# BALTIMORE GAS AND ELECTRIC COMPANY

November 13, 1979

Subject: Calvert Cliffs Nuclear Power Plant  
Units No. 1 & 2, Docket No. 50-317 & 50-318  
Fire Protection Safety Evaluation Report and  
Amendments to Facility Operating License  
File: 013-261-0, L-037-F

Reference: NRC letter dated September 14, 1979 from Reid  
to Lundvall, same subject

UNITS 1 & 2 CONTAINMENT AND AUXILIARY BUILDING PLAN AT  
69'-0" ELEVATION

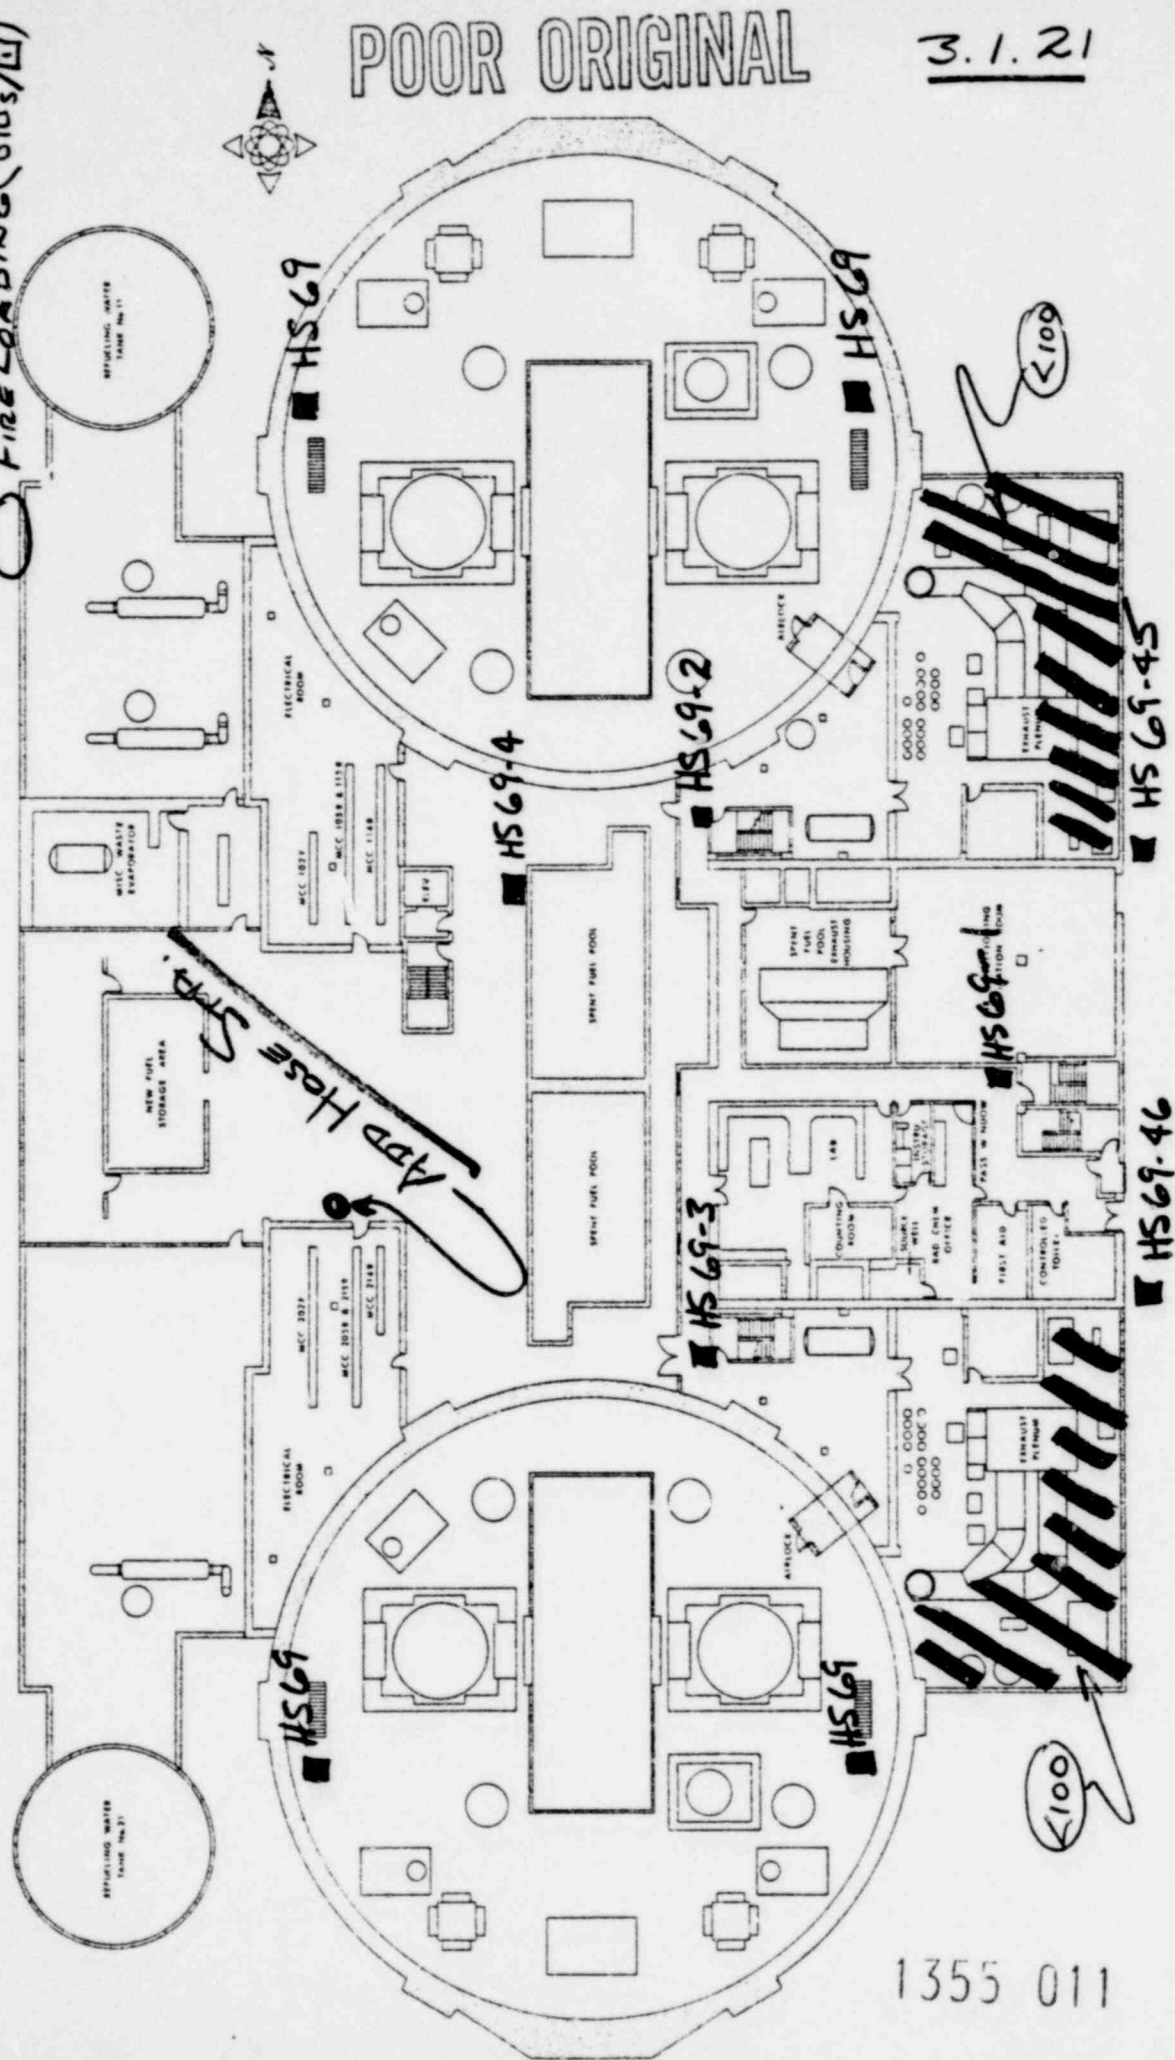
The licensee has performed hose reach tests and proposed to provide several additional hose stations. We will further evaluate this modification when the design details become available.

The results of the hose stretch test are attached herewith. Additional hose stations are to be added as shown on the attached drawings. Cross-hatched areas identify areas beyond reach of preconnected fire hose. Next to the crosshatched areas, we have identified the fire loading characterized by less than one pound of combustibles per square foot. These low fire loads do not justify extension of the standpipe and hose stations. The new hose station design and installation is shown on Figure E-1 of the Fire Protection Program Evaluation, Type C hose station detail. Fire brigade response is assured as the crosshatched areas are within rooms equipped with automatic fire detection. The fire brigade is trained in hose laying evolutions and additional hose, both 1-1/2 and 2-1/2 inch, are available in strategically located portable equipment cabinets.

Pump House SPRINKLERS  
CALVERT CLIFFS NUCLEAR PLANT

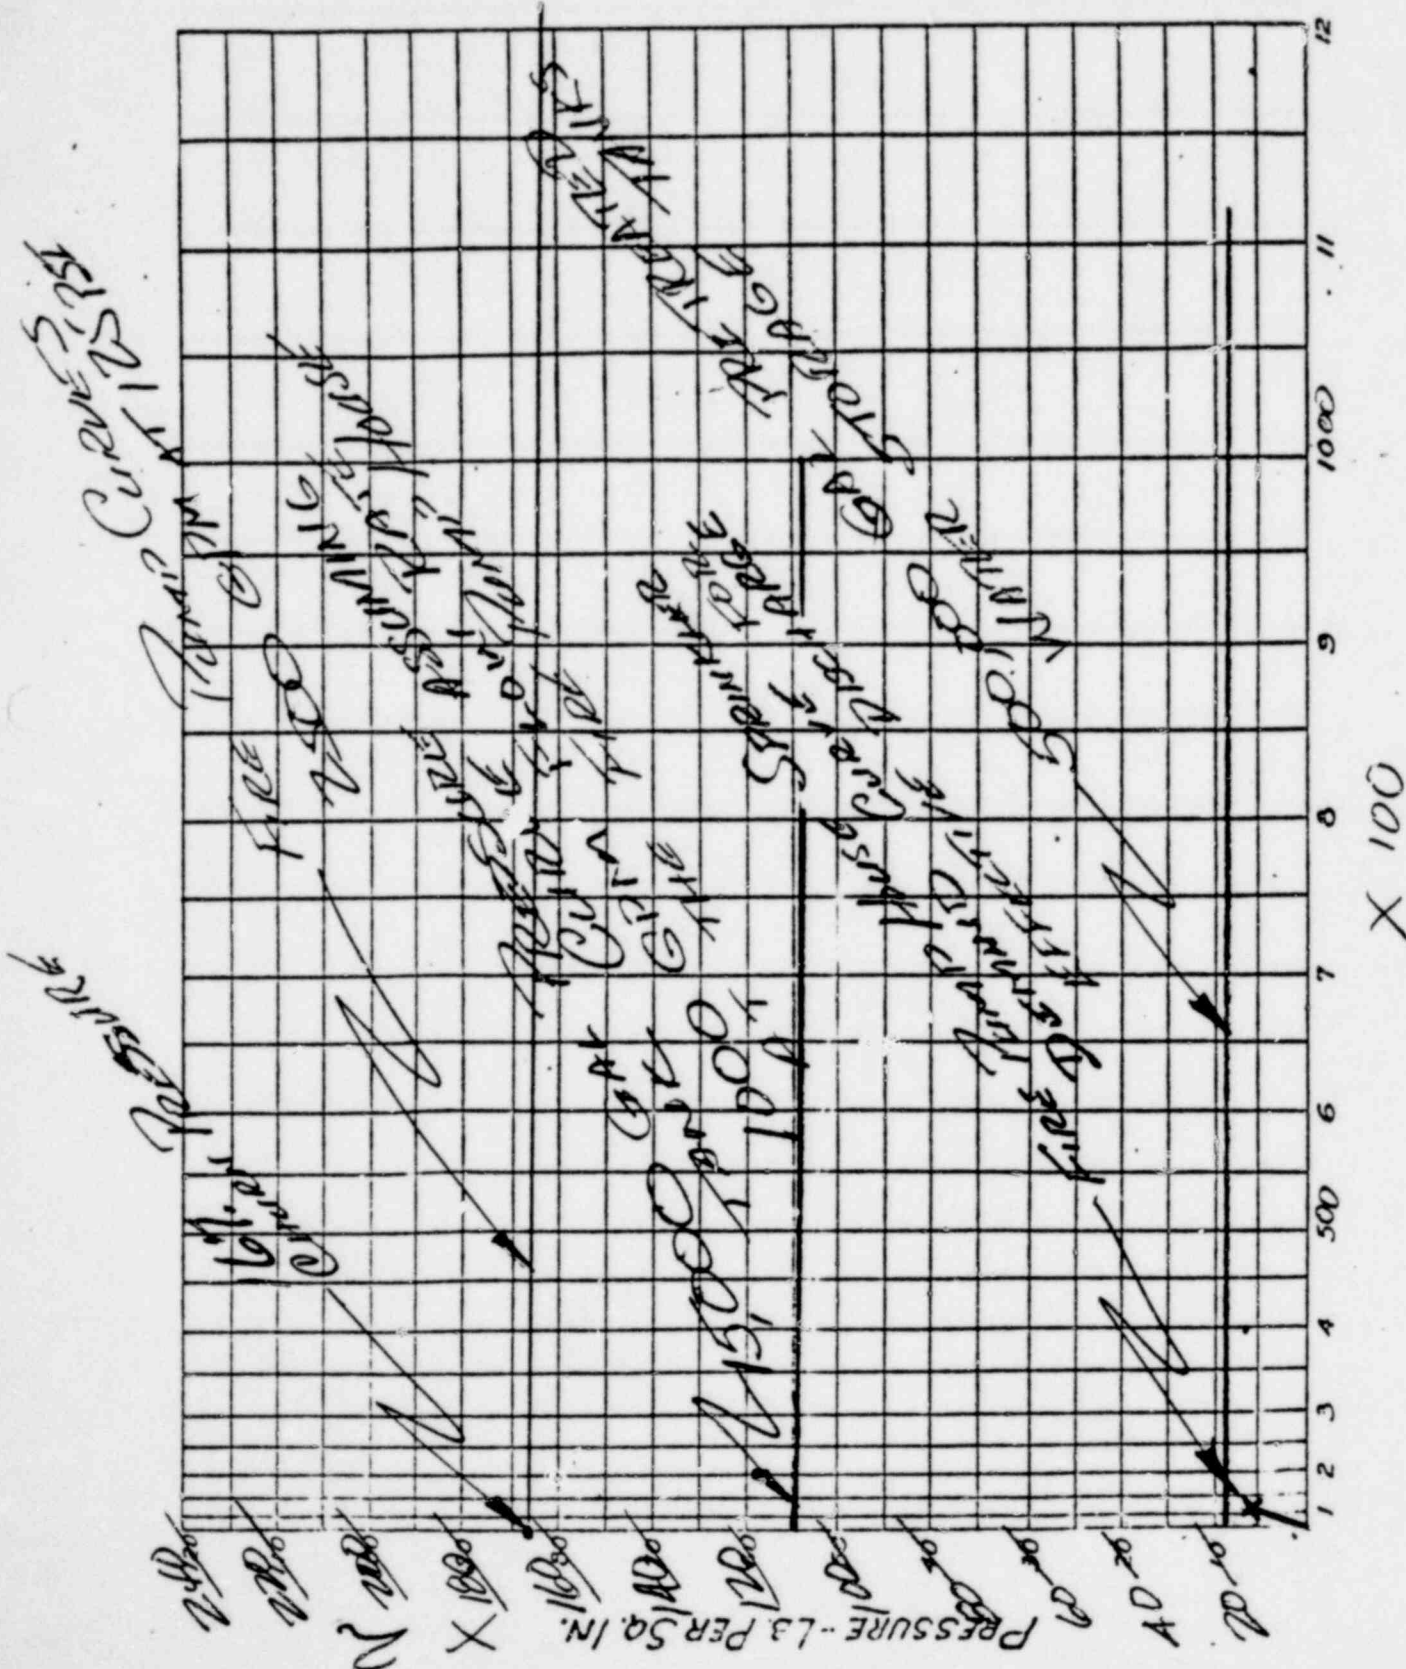
The licensee has not demonstrated that the sprinkler system installed in the fire water pump house provides equivalent protection to the 3-hour fire barrier in limiting the effect of a fire at the diesel fire pump, or its fuel tank, on the electric fire pump.

The fire pump house is protected by automatic sprinklers. A reproduction of the sprinkler design drawing is attached. The sprinkler system water supplies consist of two - 2500 gpm at 125 psi U/L approved horizontal centrifugal pumps taking suction from two - 500,000 gallon pretreated water storage tanks and a 15,000 gallon pressure tank (10,000 gallon nominal capacity) located remote from the fire pump house. A make-up pump is to be installed which also will serve as an additional water supply.

Automatic sprinklers will control temperatures and extinguish fires involving combustible liquids in the Fire Pump House. In NFPA Standard 30, the Flammable and Combustible Liquids Code, automatic sprinklers are recommended for protection of flammable and combustible liquid hazards. American Nuclear Insurers specifically recommended automatic sprinklers to protect against fires in the Calvert Cliffs Nuclear Power Plant Fire Pump House.

∴ 15.23 PSI REPRESENTS THE MIN. PRESS REQUIRED TO PROVIDE EFFECTIVE DISCHARGE FROM AUTO. SPRINKLERS. THIS REQUIREMENT IS SATISFIED BY:
